UNITED STATES PATENT AND TRADEMARK OFFICE

10/663,889

Office Action Summary	Application No. 10/663,889	Applicant(s) MCCLURE ET AL.	
	Examiner Justin M. Larson	Art Unit 3727

DETAILED ACTION

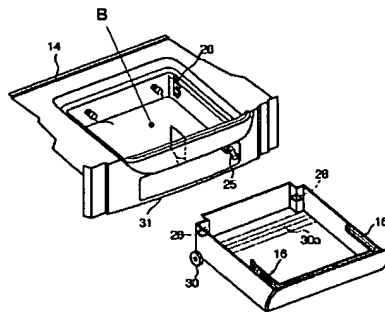
Regarding claim 4, the support member of Fukushima et al. includes an outwardly projecting protrusion (28) and the bottom portion (B, Figure below) of the shell includes an inwardly extending recess (26) adapted to receive the protrusion.

Regarding claim 18, the bottom portion (B, Figure above) of the shell of Fukushima et al. includes the recessed region (26).
